Addendum No. 4

BND SHOP VEHICLE WASH BAYS

August 30, 2021

NORTH ELEVATION
Scale: 1" = 10'

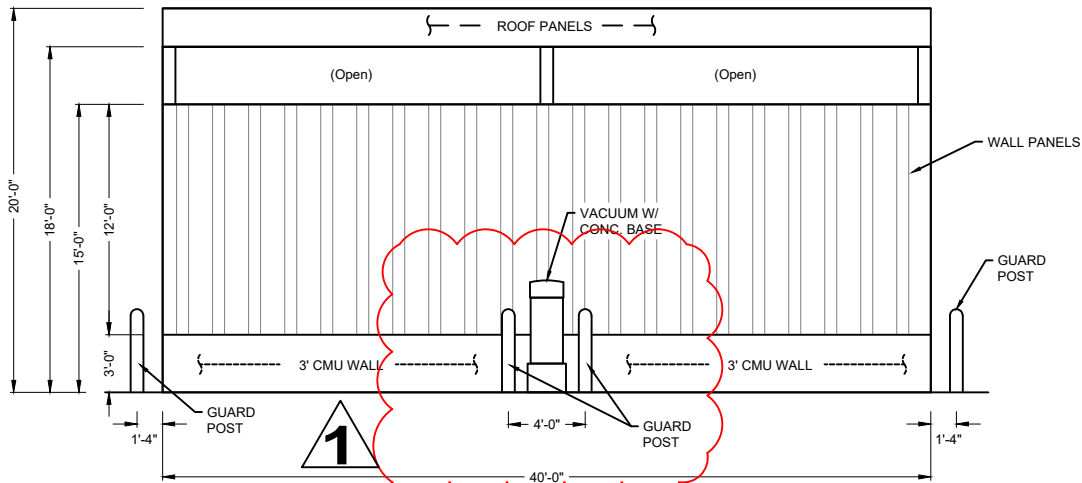
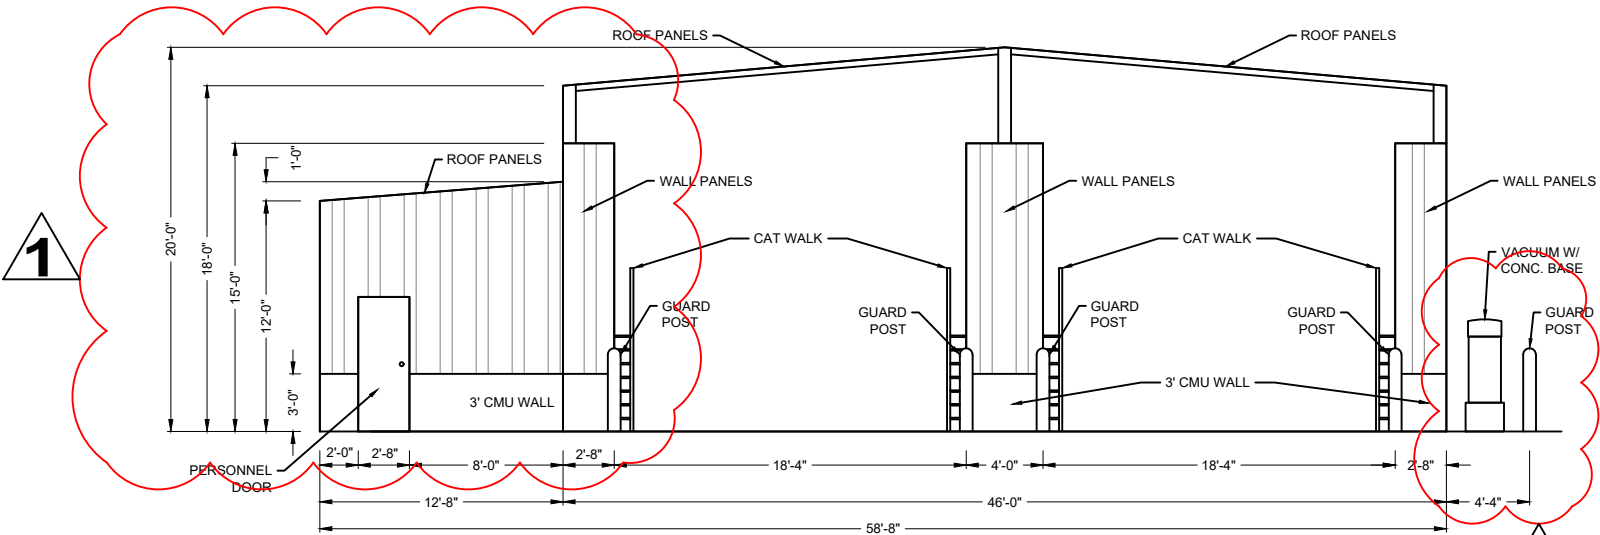
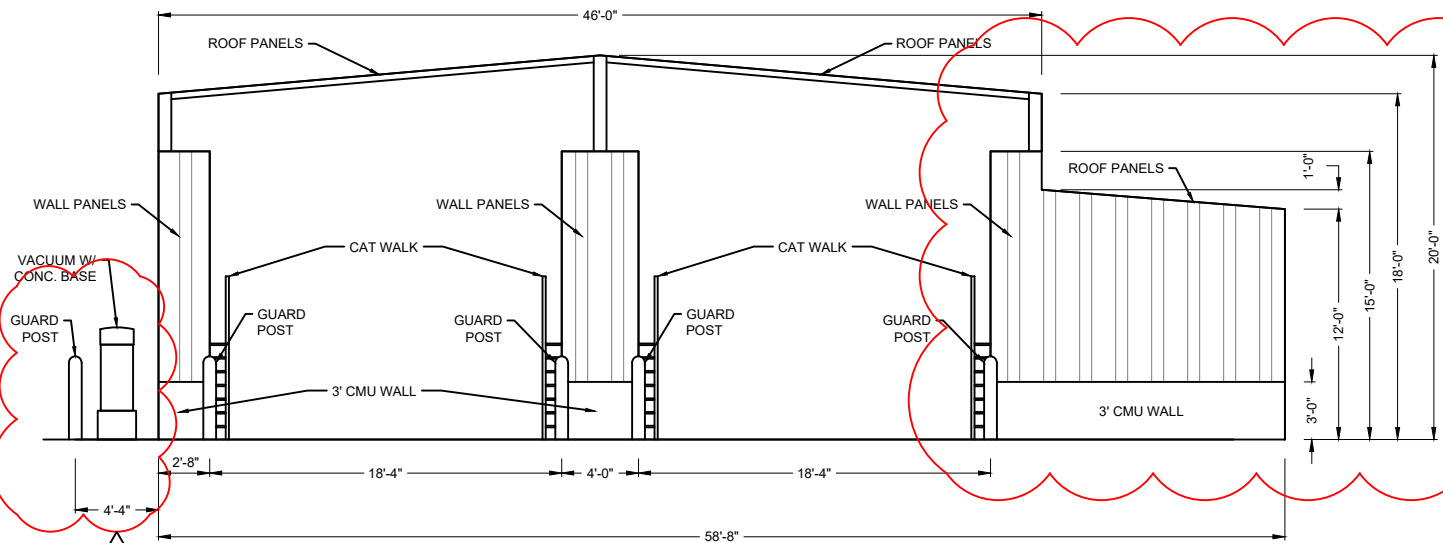
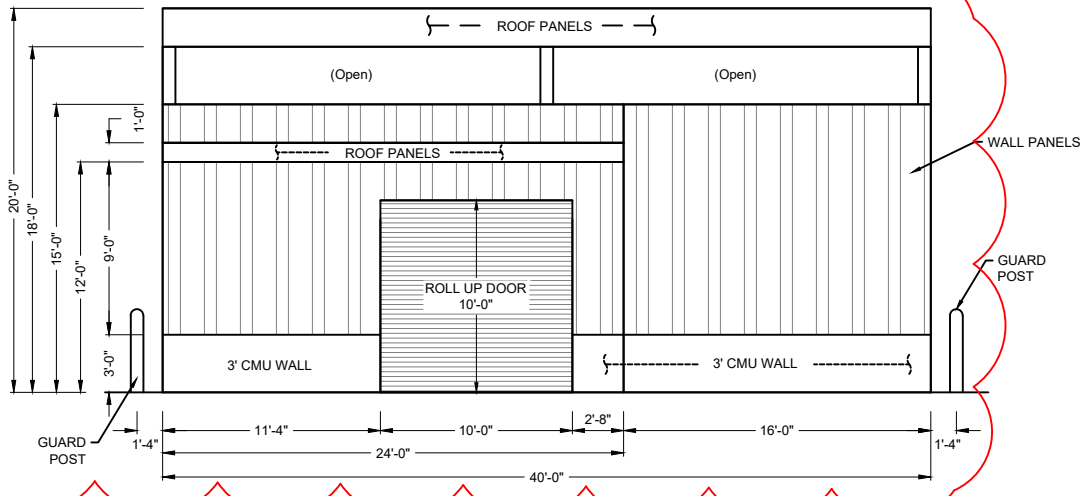
- a. The **Bid Drawings** have been changed to include:
 1. The **Metal Structure** above the concrete, inclusive of beams and sheet metal. The contractor shall furnish and install the metallic roof structure. Such structure must meet or exceed the specified materials and dimensions shown in the revised Bid Drawings. Contractor shall submit shop drawings of the metal structure for approval by Owner prior to installation. Contractor shall secure any required permits from the Cameron County Building Permits office with an on-staff or subcontracted certified plumber as needed.

SECTION DETAILS

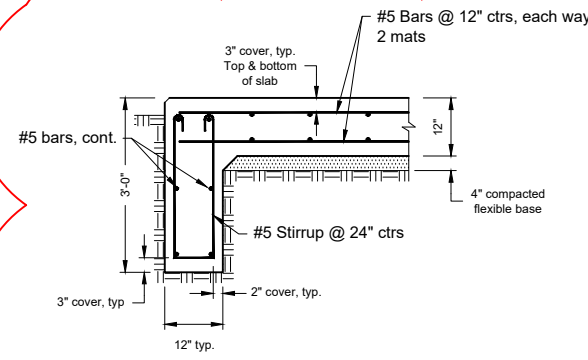
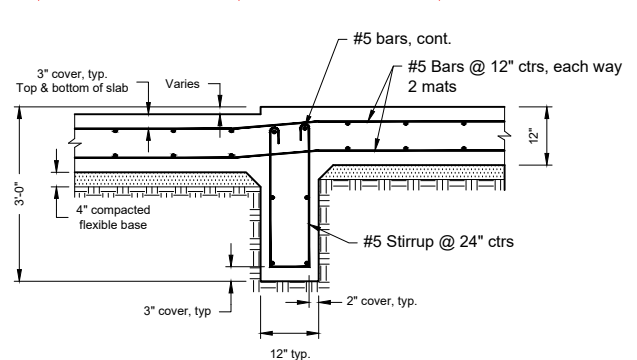
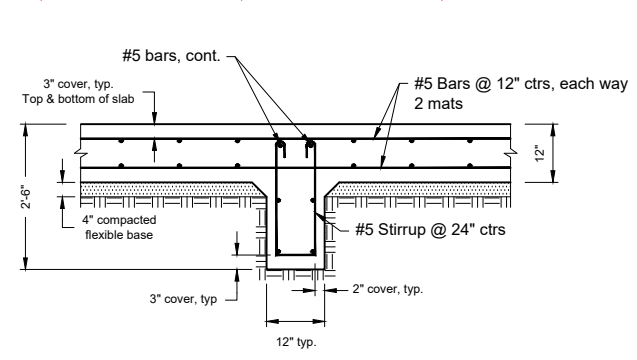
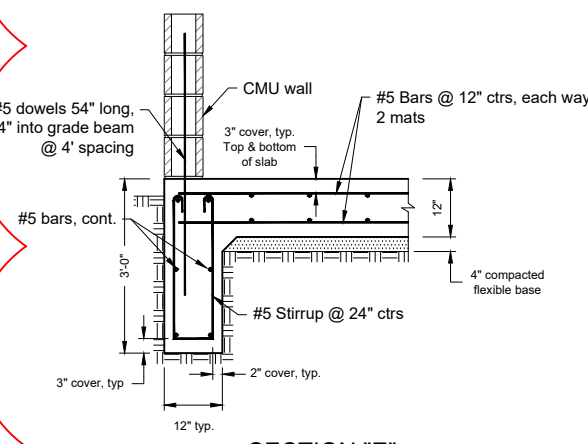
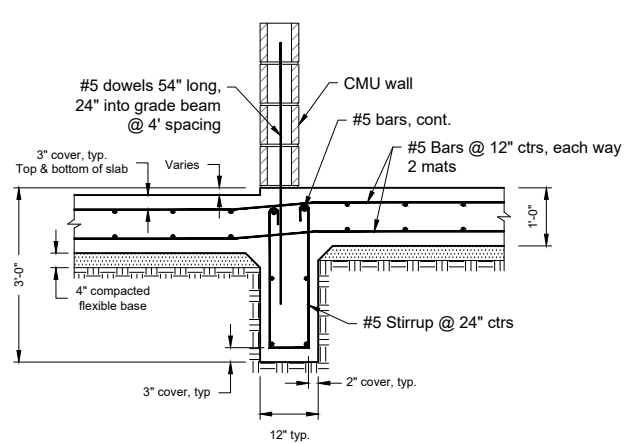
10. Please provide a "Concrete Wall Detail" for the thickness and reinforcement and BND's metal building bolt location for size of anchor bolts to be installed.	Concrete wall detail is shown in sheet 6. No anchor bolts will be required, the steel column will be embedded into the concrete footing.

13. Please provide wall detail above perimeter and interior beams.	Concrete wall detail is shown in sheet 6.

SECTION "D"
Scale: N.T.S.

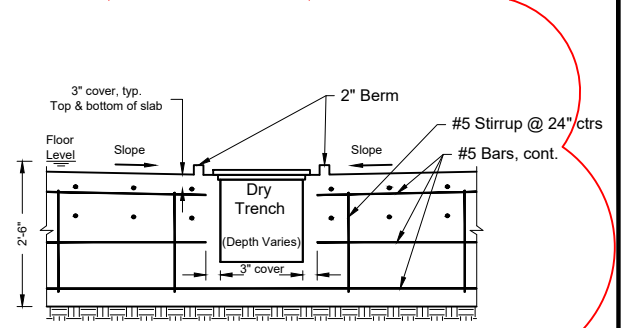
9. Can you clarify detail for the conflict at the slope drain and the "E" Beam detail found on sheet 5? I assume the beam will be under the drain slope with #5 rebar offset.	Cross Section D sheet 6 specifies the dimensions and rebar placement for the beam under the drain trench.

CAI WALK DETAILS

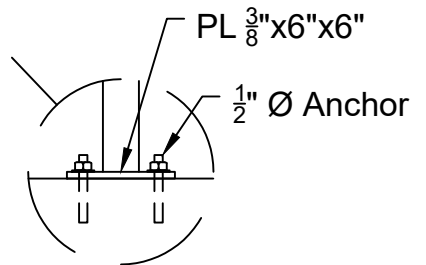
5. Extended time to open bids and execution days?	Completion time for this project is 45 days, no additional time is added.
6. Provide specs on grate.	Grate and steel specifications can be found in the notes section on drawing sheet 3 for the wash bay and sheet 7 for the cat walks.

ELECTRICAL PLAN

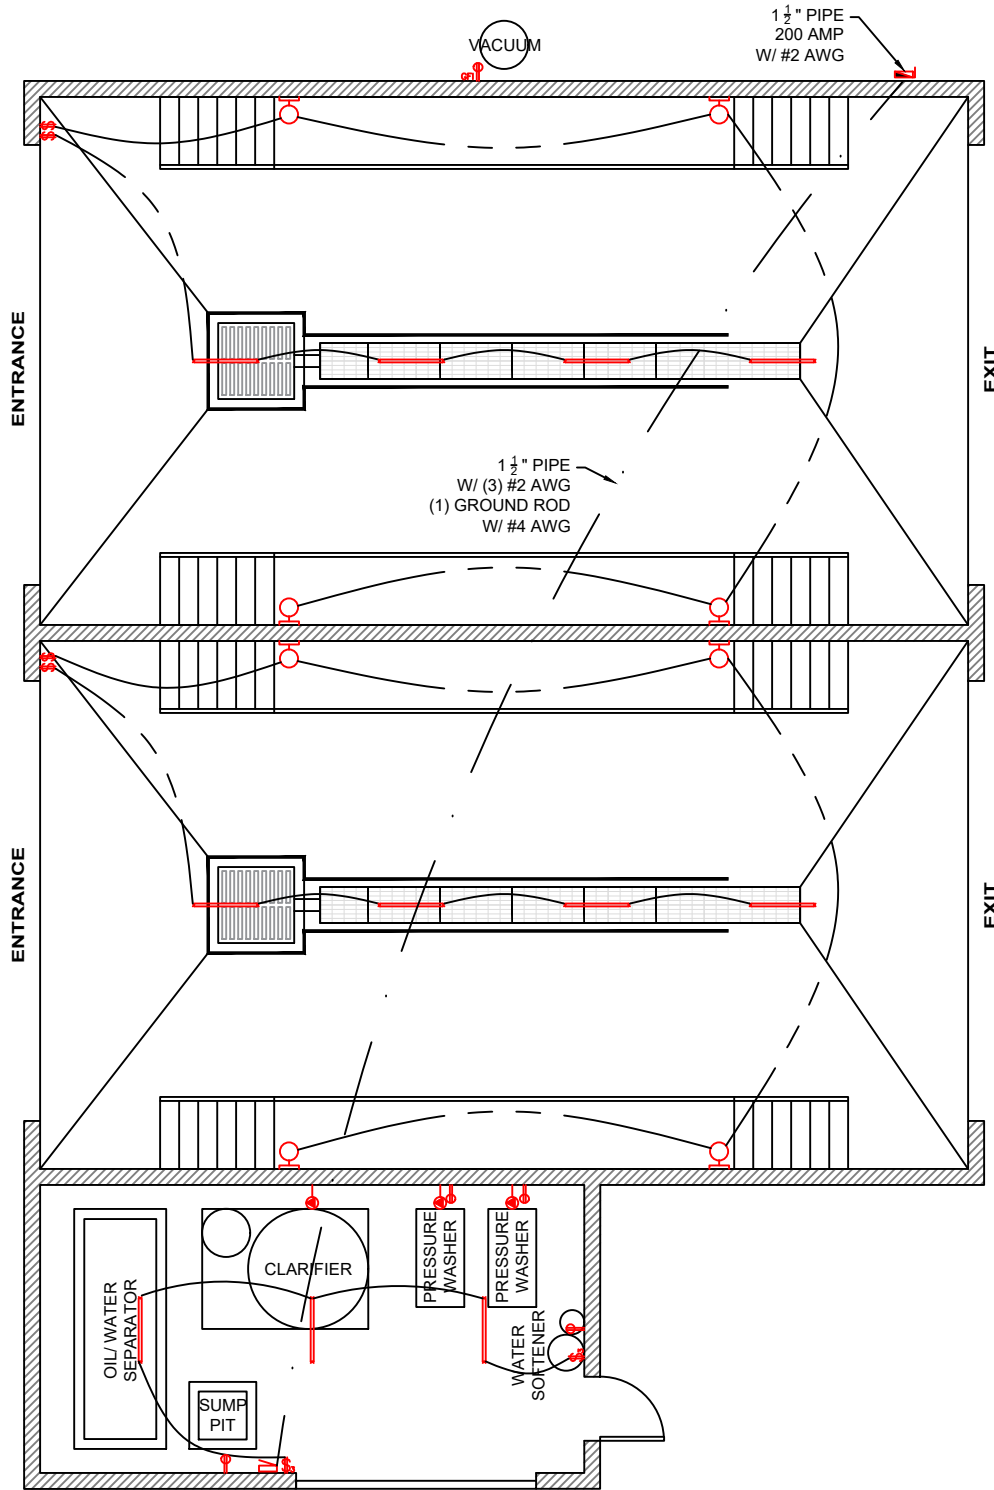
BIDDERS' QUESTIONS	OWNER'S RESPONSES
1. Define if the electrical work will be a part of the scope of work.	Yes, the electrical work will be part of the scope. Details and specifications attached on the drawings. Please refer to Drawing Sheet 8.
